# Access Compliance Report

## Public Rights-of-Way

### (Curb Ramps)

Intersection ID: 10040558	Main Street: W_8TH_ST	Cross Street: N/A	Location: E
ADA ID: D0B9091F1239	Ramp Type: Directional2	Initial Pass/Fail: Pass	Overall Compliance: No
			Severity Score: 10.25

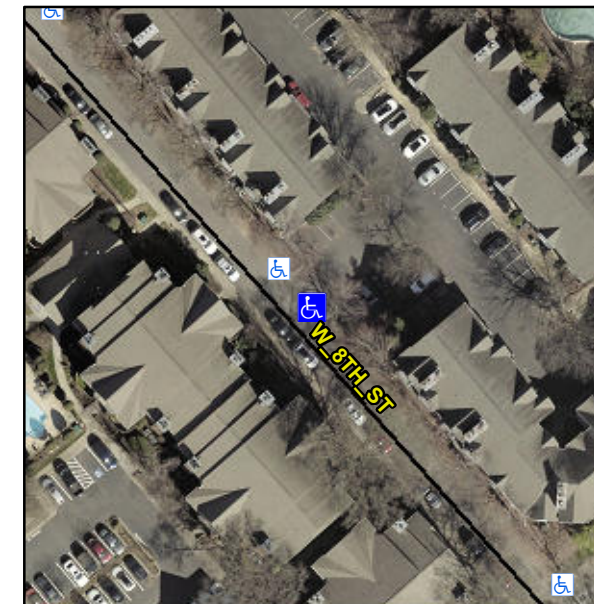
**R304.5.3, R305**

Compliance	Description	Data	Compliance	Description	Data
N/A	Ramp Length (in)	46.0	Yes	Grade Break?	Yes
Yes	Ramp Width (in)	53.0	Yes	Grade Break Slope (%)	2.0
Yes	Ramp Slope (%)	4.8	Yes	Grade Break XSlope (%)	1.1
No	Ramp XSlope (%)	3.3			
N/A	Flare Type LT	N/A	N/A	Flare Type RT	N/A
N/A	Flare Slope LT (%)	N/A	N/A	Flare Slope RT (%)	7.7
N/A	Flare Traversable LT?	N/A	N/A	Flare Traversable RT?	Yes
Yes	Landing Length (in)	60.0	No	DWS Provided?	No
Yes	Landing Width (in)	59.0	N/A	DWS Contrast?	No
Yes	Landing Slope (%)	0.1	N/A	DWS Length (in)	N/A
Yes	Landing X Slope (%)	0.2	N/A	DWS Full Width?	No
N/A	Landing Curb? (Y/N)	N/A	N/A	DWS Offset LT (in)	N/A
N/A	Shared Landing?	No	N/A	DWS Offset RT (in)	N/A
Yes	Gutter Ponding?	No	Yes	Gutter Slope (%)	4.0
Yes	Gutter Lip Ht (in)	0.0	Yes	Gutter X Slope (%)	0.8
N/A	Painted X Walk1?	No		Road Slope (%)	0.9
	X Walk 1 Direction	To NW		Road X Slope (%)	0.2
	X Walk 1 Width (in)	N/A		Clear Space?	Yes

**Remove & Replace Entire Ramp.**
